Jacobsen Information Bulletin

Product Type: Jr. Sodcutter

Bulletin No: C-037-05

Rear Wheel Spacer

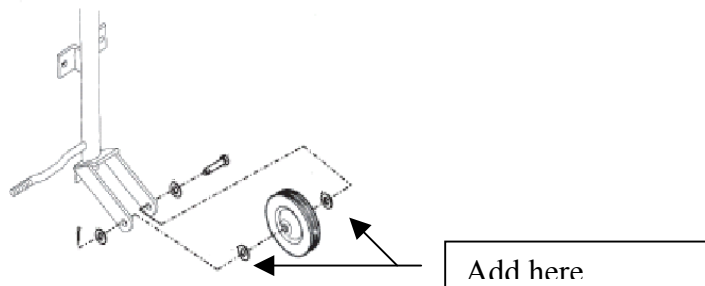
ISSUE:

Rear Wheel not being held in place, allowing the bearing to be damaged.

CORRECTION:

Install 1 –2 spacers part number 64163-67 per side as shown in drawing, to shim rear wheel to forks within a 1/8" of play. Try to center wheel in between forks as much as possible.
